SUBJECT: ARKANSAS NUCLEAR ONE, UNIT 2 – SUMMARY OF CONFERENCE CALL
WITH ENTERGY OPERATIONS, INC. TO DISCUSS 2014 STEAM
GENERATOR TUBE INSPECTIONS (TAC NO. MF3897)

SUMMARY OF MAY 27, 2014, CONFERENCE CALL
REGARDING SPRING 2014 STEAM GENERATOR INSPECTIONS

Enclosure 2
Licensee Summary of Discussion Points as of May 27, 2014

STEAM GENERATOR TUBE INSPECTION DISCUSSION POINTS
ENERGY OPERATIONS, INC.
ARKANSAS NUCLEAR ONE, UNIT 2

ANO2 SG Primary to Secondary Leak Rate (H-3) Gallons per Day (GPD)

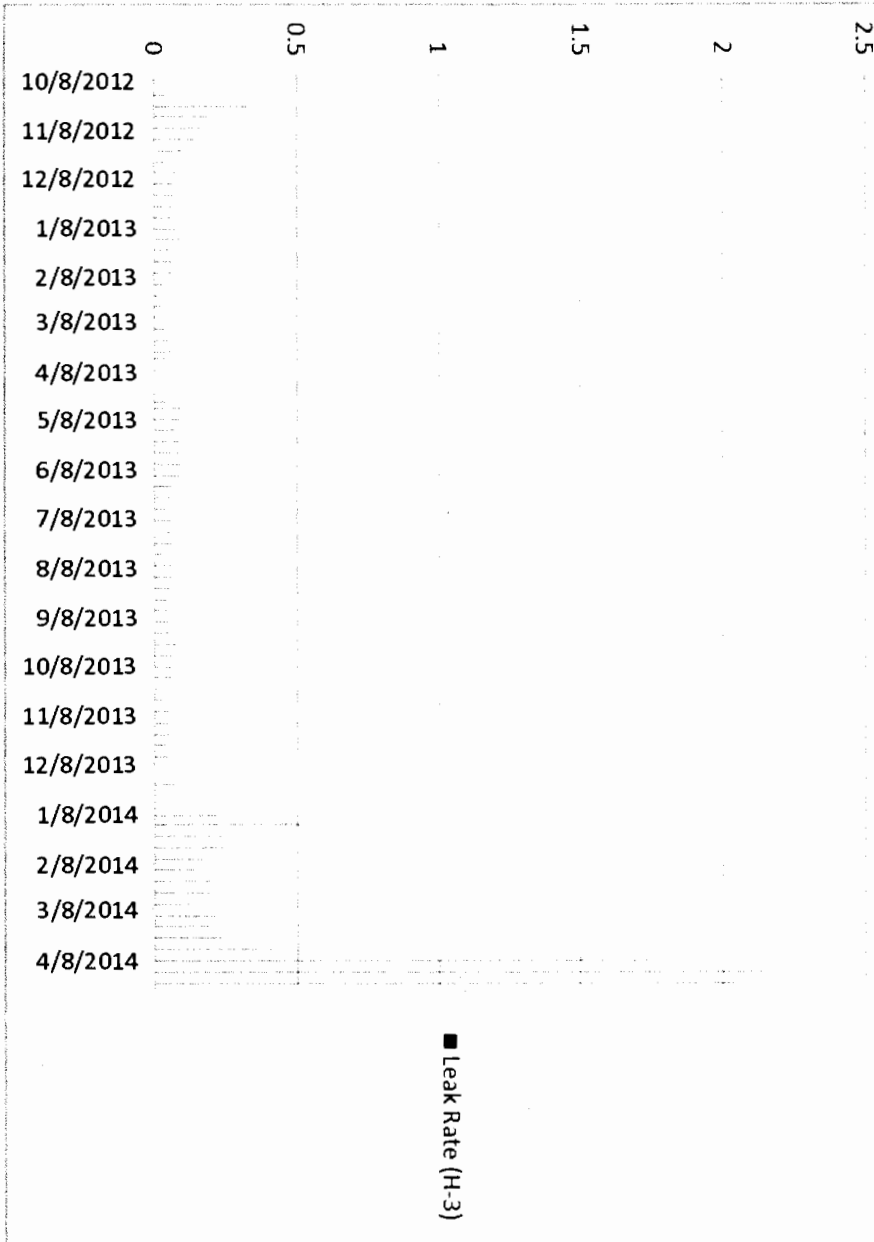
- In the ANO-2 SG Primary to Secondary Leakrate (H-3) Gallons per Day (GPD) graph on page 7 of Enclosure 2, the y-axis units are GPD.
- Verification of anti-vibration bar (AVB) positions will be performed with eddy current auto analysis after the SG tube inspections are complete. The estimated time to complete the verification is 2 weeks.

No indication of primary-to-secondary leakage present prior to the current refueling outage (2R23).

(Argon – 41 less than minimum detectable, Tritium ~ 1 gallon per day)
